RS-12-021

Clinton Power Station, Unit 1
Facility Operating License No. NPF-62
NRC Docket No. 50-461

Subject: Additional Information Related to License Amendment Request to Modify
Technical Specifications Section 3.8.1, "AC Sources – Operating,"
(TAC NO. ME6876)

Figure 1: Voltage Profile for the CPS Division 1 DG from December 2011 Integrated Test

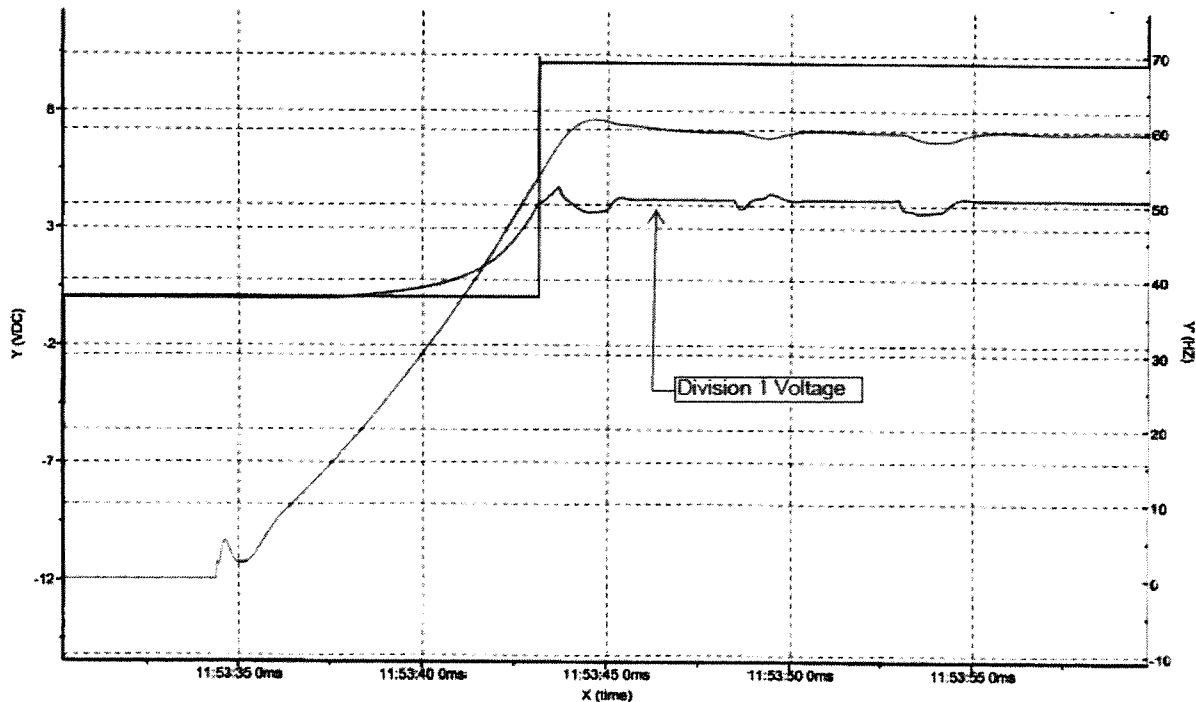
- b. The voltage profiles(s) at 4160 V safety-related buses when powered by EDGs, during the sequencing of large safety-related loads for a loss of coolant accident signal, based on analysis or test.***

The voltage profiles for all three divisions from the integrated tests conducted in December 2011 are shown in Figures 1, 2, and 3 below for the Division 1, 2, and 3 emergency diesel generator (EDG), respectively. These voltage profiles include EDG starting and sequencing of large safety-related loads. As shown on the figures, the Division 1 EDG output voltage stabilized at approximately 4220V, the Division 2 EDG output voltage stabilized at approximately 4230V and the Division 3 EDG output voltage stabilized at approximately 4140V.

In summary and as shown on Figures 1, 2, and 3 from the integrated testing, the voltages for all three EDGs stabilized below 4300V on startup and following sequencing of major safety-related loads. When accounting for instrument uncertainties, Figures 1, 2, and 3 demonstrate that all three EDGs are operated below 4300V during normal operation and during recovery from transient conditions.
